STPN-052-1(113)-2J-49
 U.S. 52
 12/17/24

*U.S. 52 from Mississippi River Bridge
 to
 Overflow Bridge North of Sabula*

FIELD EXAM MEETING MINUTES

Subject: Meeting Minutes
US 52 Causeway D02 Design Field Exam

Attachment 1 – Proposed Construction Sequence

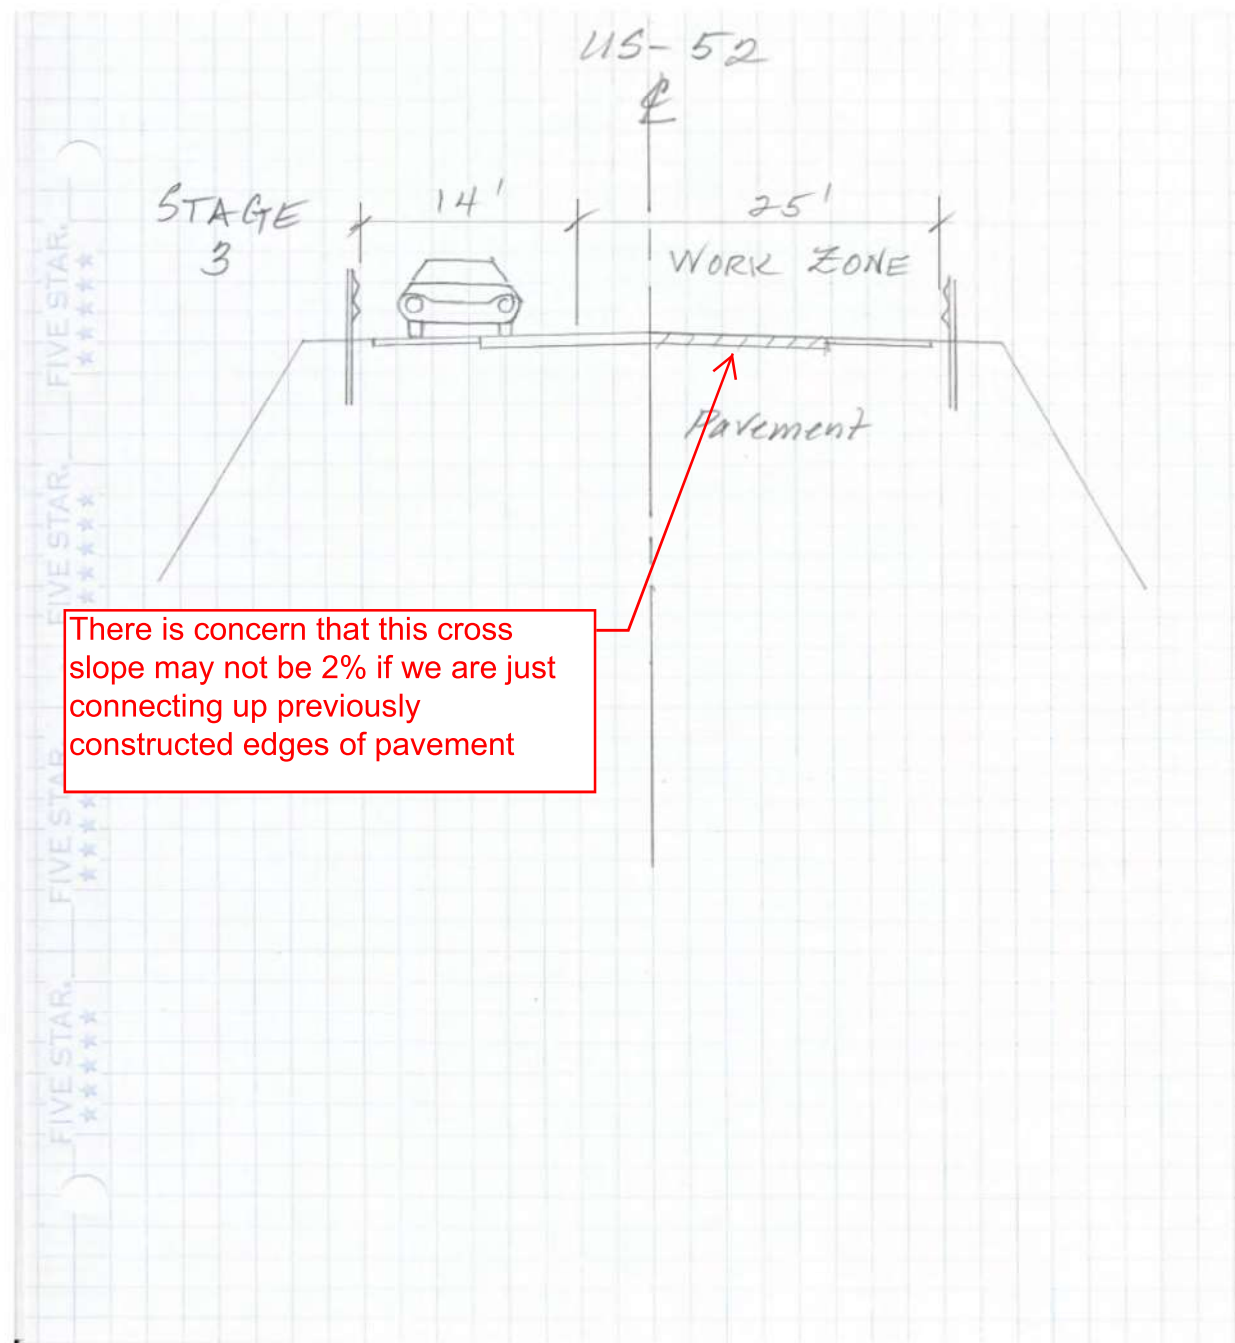
There is concern that this cross slope may not be 2% if we are just connecting up previously constructed edges of pavement

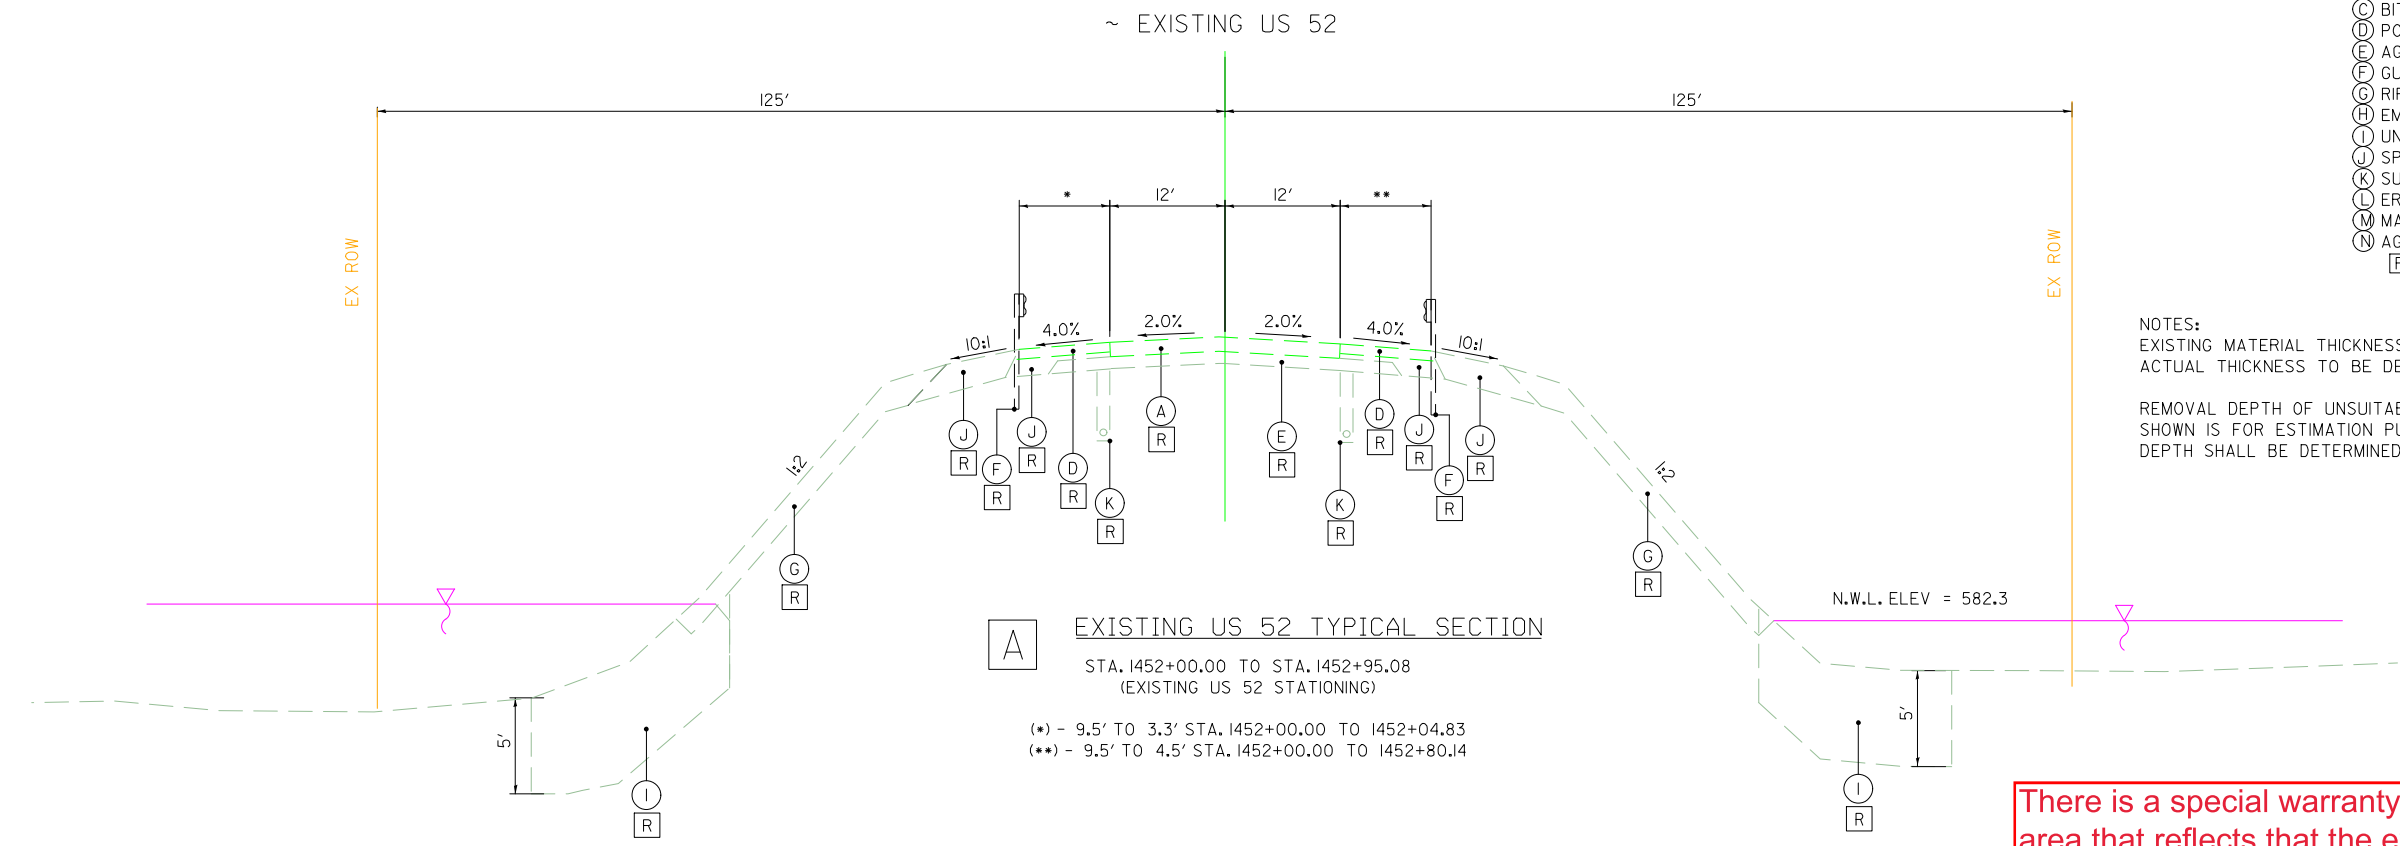
EB curve offset to guardrail

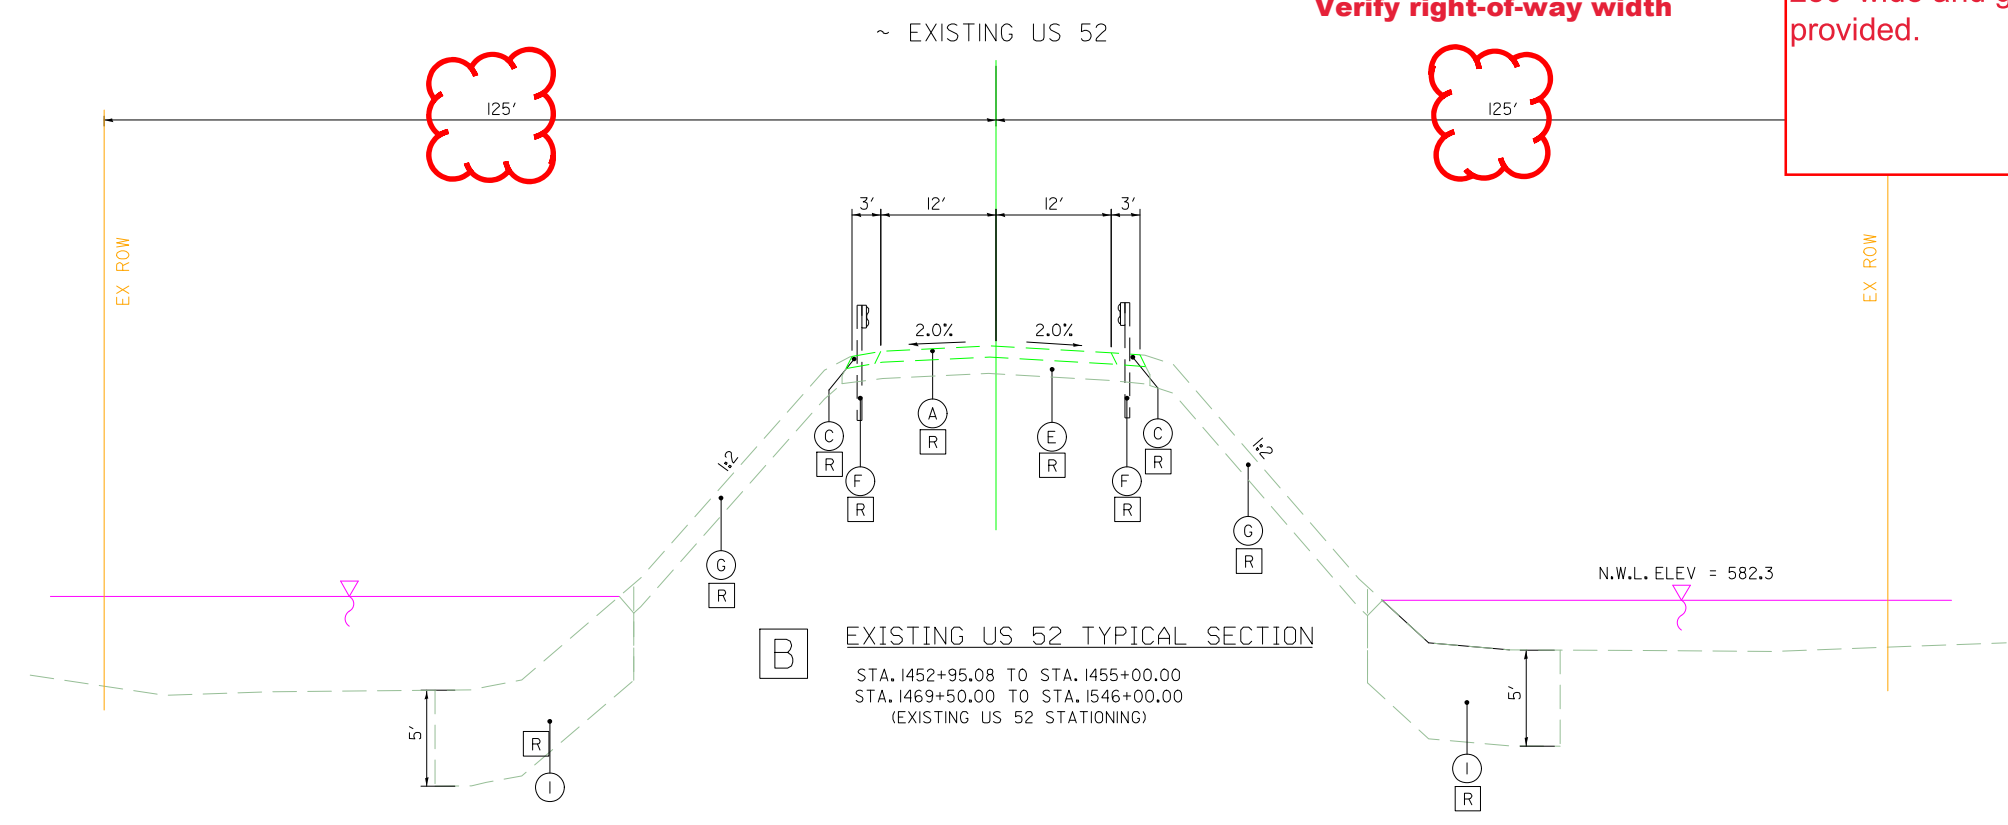
Verify right-of-way width

There is a special warranty deed for this area that reflects that the existing ROW is 250' wide and greater. This will be provided.

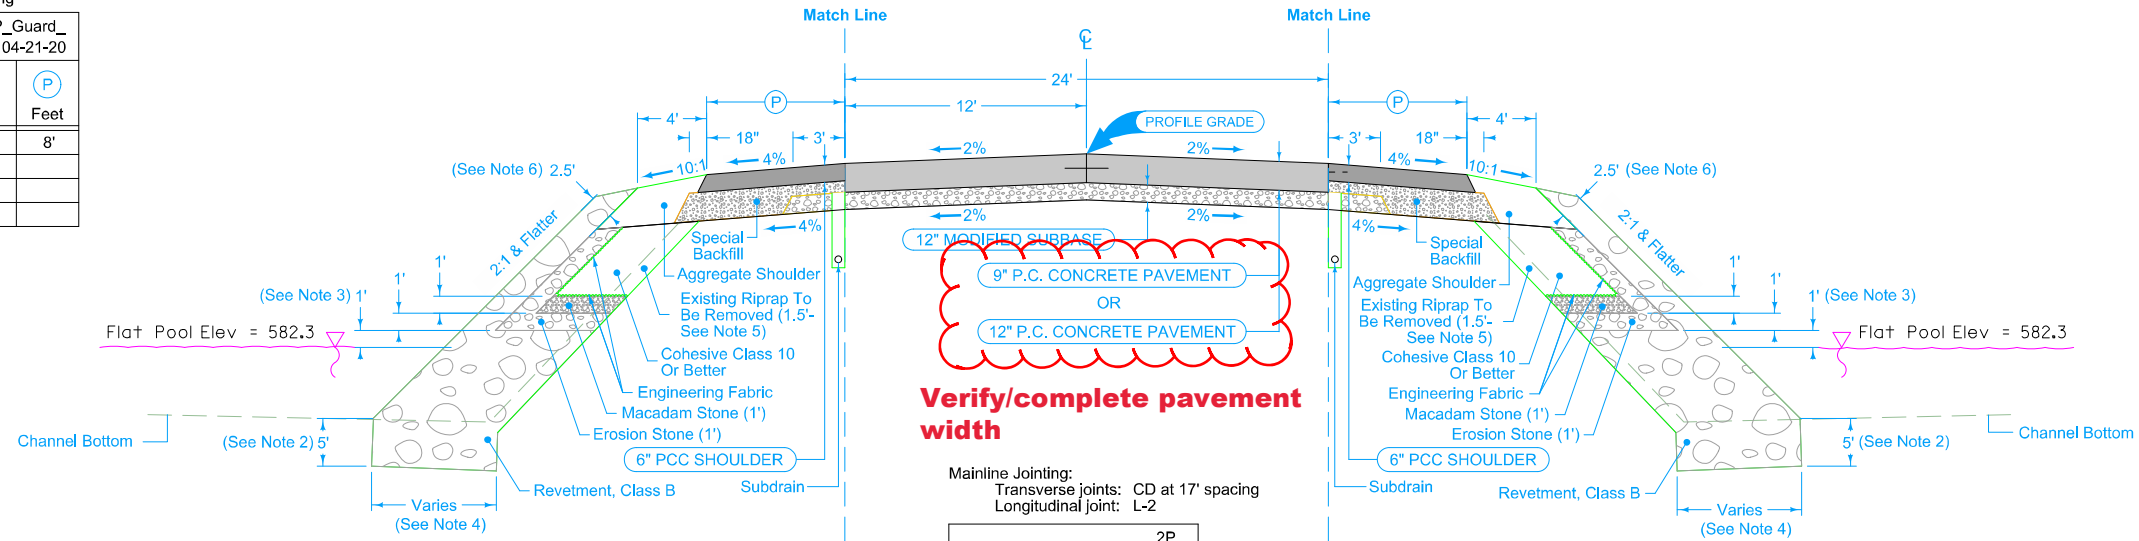
Verify/complete pavement width

The proposed fill section is identical to that proposed for the overflow bridge.

PHASE 1, STAGE 1A
US52 CAUSEWAY

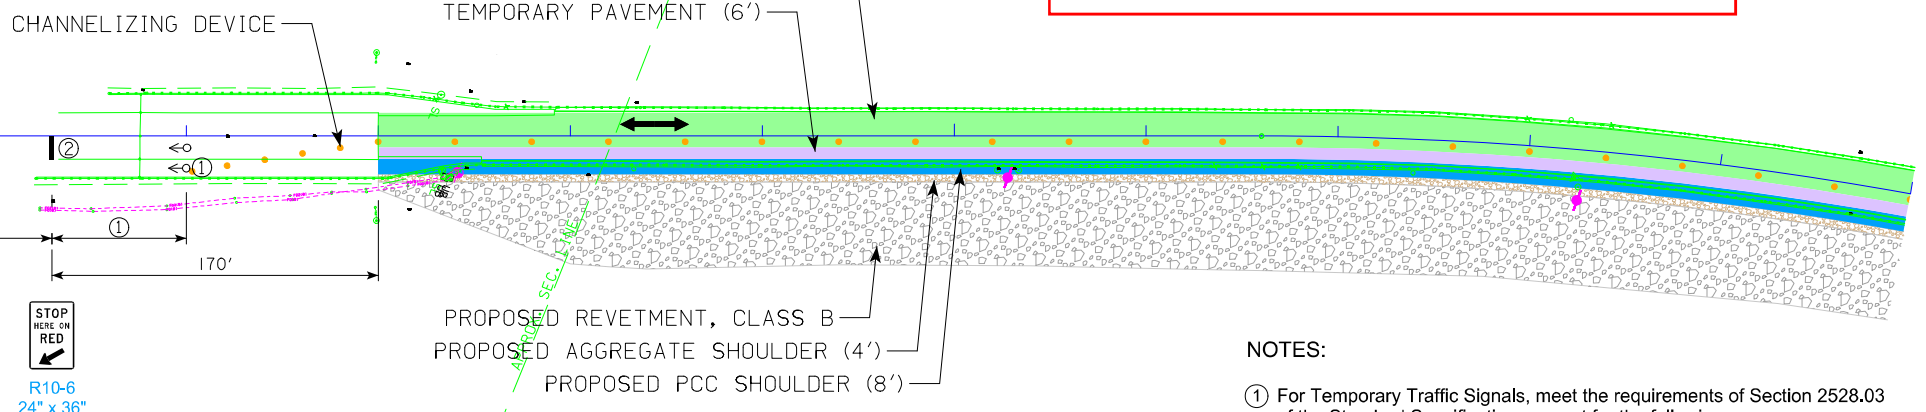
Discuss whether construction should proceed from south to north or vice versa
Roger suggested fill material would come from Illinois and if so construction should start at north end and proceed south in order to preserve existing pavement. Contractor fill material quarry unknown.

No need to revise N-S construction sequence.
Contractor can submit their own staging plans.
Reflect this in the staging notes

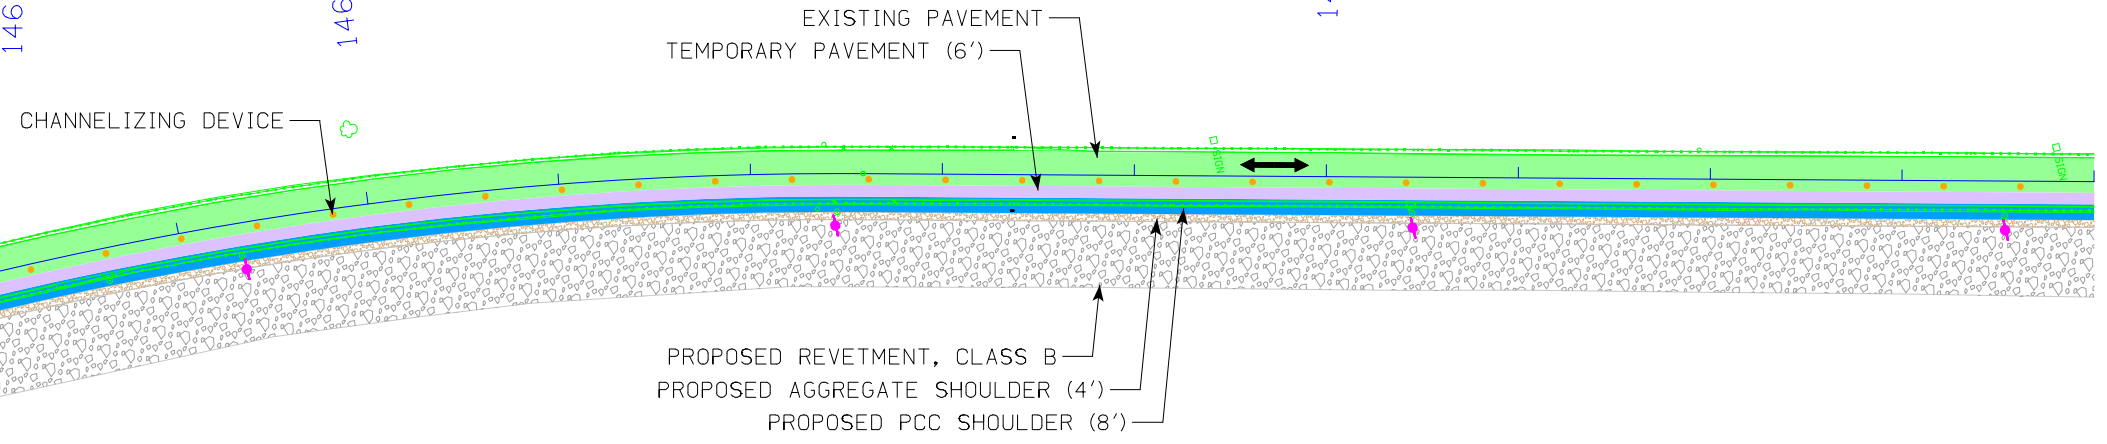
No discussion of using a higher posted speed during construction. Use 35 MPH.

PHASE 1, STAGE 1A
US52 CAUSEWAY

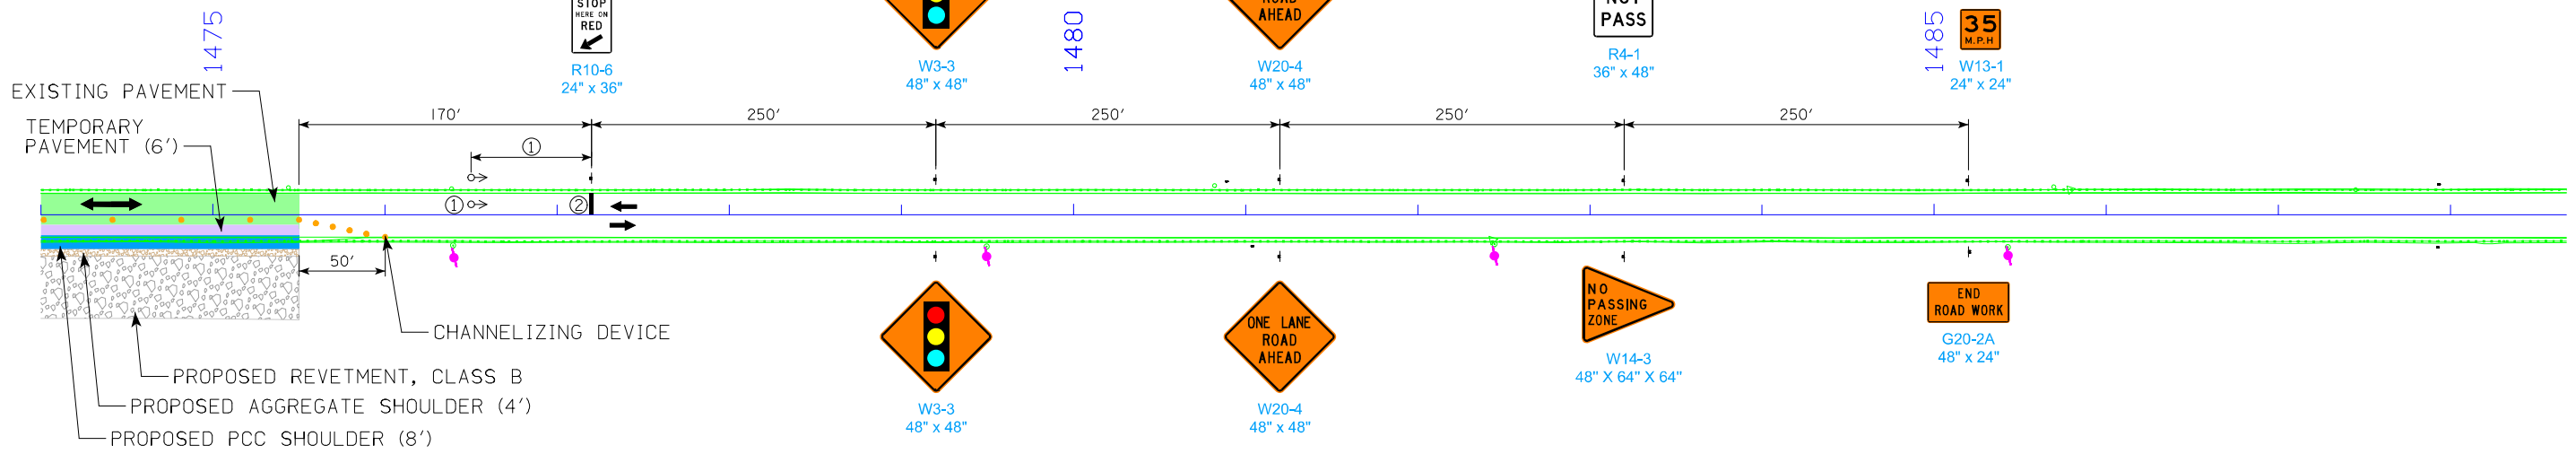
For construction signage consider skid mounting or providing some sort of movable signage to make relocation easier.
